April 6, 2020

Subject: Bangor Savings Bank Windham Branch/Office Building
745 & 747 Roosevelt Trail, Windham, Maine
Response to Staff Review Comments

BANGOR SAVINGS BANK WINDHAM BRANCH/OFFICE BUILDING 745 & 747 ROOSEVELT TRAIL WINDHAM, MAINE	
SITE LAYOUT PLAN	
	DESIGN BY: AML
	DRAWN BY: SJM
	DATE: 1/2020
	CHECKED BY: BDP
LMN: SITE	
CTB: SME-STD	
JOB NO. 19128.00 DWG FILE BASE	
C-103

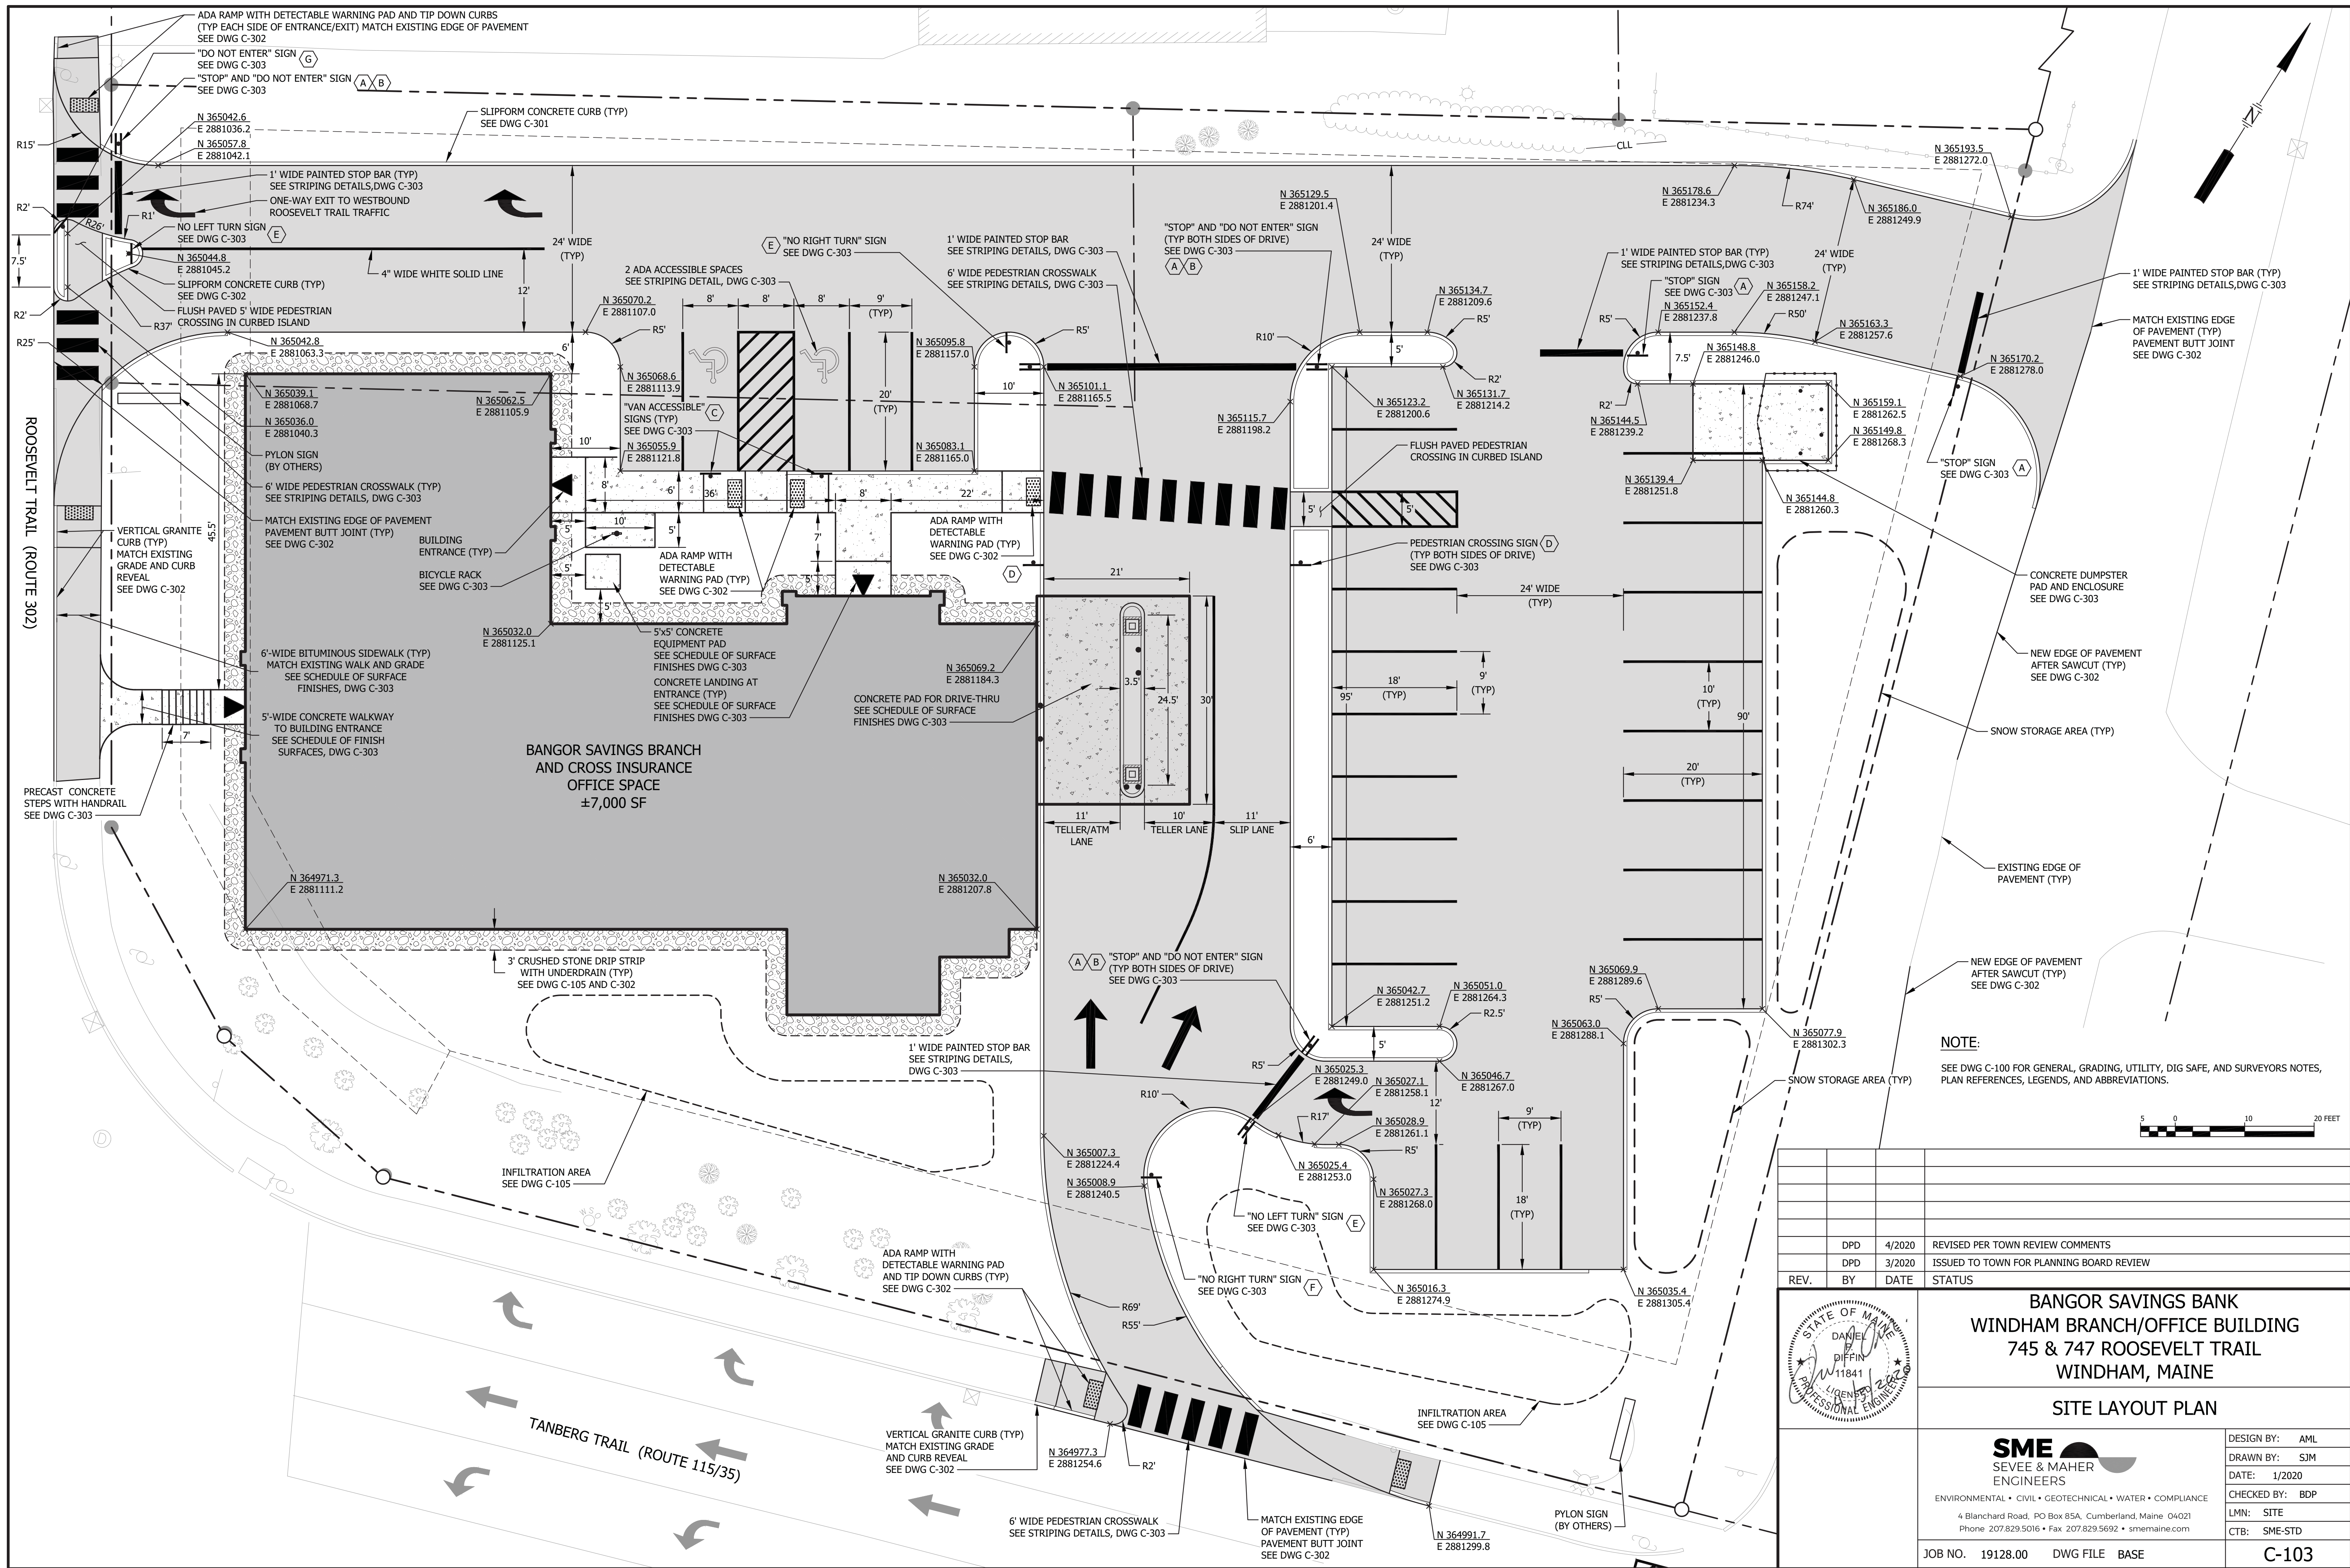
6. **It is not clear from the plan that the designated right-turn-only entrance from northbound 302 is going to prohibit traffic from turning left from southbound 302 across northbound 302, to enter the site. Will the applicant please clarify what prohibits this movement and if it is adequate?**

9. It should be noted that the proposed access management measures (reduction of driveways and restriction of movements) to this corner should have a net positive impact to the overall area, reducing potential conflicts and improving safety. However, the applicant should

address the Town's double frontage requirements. We recommend the applicant revisit the channelization of the proposed driveways to improve the enforcement of right turn movements only. As currently shown at both driveways, the restrictions do not appear to be prohibitive enough.

SME Response: The geometry of the entrance island has been modified to further discourage entrance across the northbound travel lane from southbound US-302. Project plans have been updated to reflect this change. Copies of the updated plan sheets are attached for reference. We believe these modifications will keep alert, responsible drivers from using the entrance inappropriately.

SME has updated entrance geometry at the US-302 and ME-115 site entrances to improve access management and access drive channelization. Copies of the updated plan sheets are attached for reference. We believe these modifications will encourage alert, responsible drivers to follow proposed circulation routes on the property and at entrances and exits to the public right of way.
